<b>DOCKETED</b>	
<b>Docket Number:</b>	18-IRP-01
<b>Project Title:</b>	Integrated Resource Plan
<b>TN #:</b>	264936
<b>Document Title:</b>	HHP Response to CEC Staff July 2025
<b>Description:</b>	N/A
<b>Filer:</b>	Mallory Albright
<b>Organization:</b>	San Francisco Public Utilities Commission
<b>Submitter Role:</b>	Public Agency
<b>Submission Date:</b>	7/21/2025 12:07:35 PM
<b>Docketed Date:</b>	7/21/2025

**RE: Emails dated June 24, 2025 and July 3, 2025**

Please find Hetch Hetchy Power's (HHP's) responses to your emails requesting information on Hetch Hetchy Power's most recent Integrated Resource Plan (IRP) below.

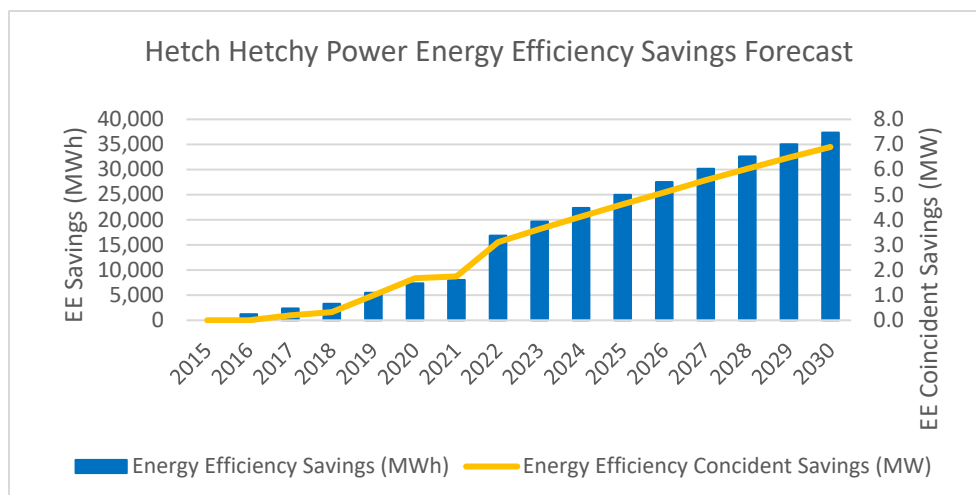
- CEC Question: Can you provide historical data and projection of cumulative additional achievable energy efficiency (AAEE) savings for years 2015 through 2029?** This info could be provided as a figure or data table showing energy efficiency savings each year in GWh, and/or cumulative savings. This would help support the conclusion of meeting the cumulative AAEE savings of 37 GWh for SFPUC in 2030 relative to the 2015 baseline as shown on page A-21, Table A-11 in Revised SB 350 Doubling Energy Efficiency Savings by 2030 (Revised SB 350 Report), California Energy Commission (October 2017).

**HHP Response:** The figure below includes HHP's historical and projected cumulative energy efficiency savings through 2030. Compared to HHP's cumulative AAEE savings target of 37 GWh in 2030 pursuant to the Revised SB 350 Report, HHP projects cumulative energy efficiency savings will reach 37.4 GWh in 2030.

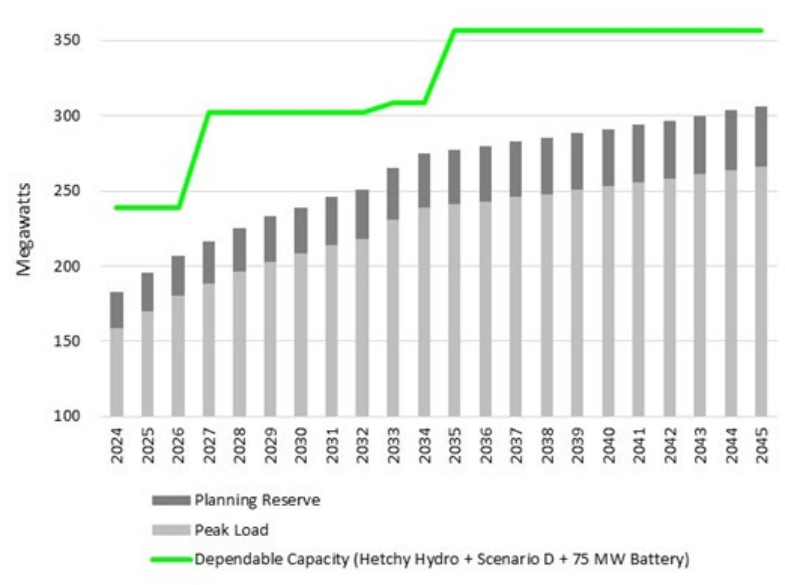
- b. Please provide a figure similar to Figure 4-5 for Scenario D or whichever scenario is represented in the Standardized Tables.

**HHP Response:** Here is an updated Figure 4-5 with Scenario D.
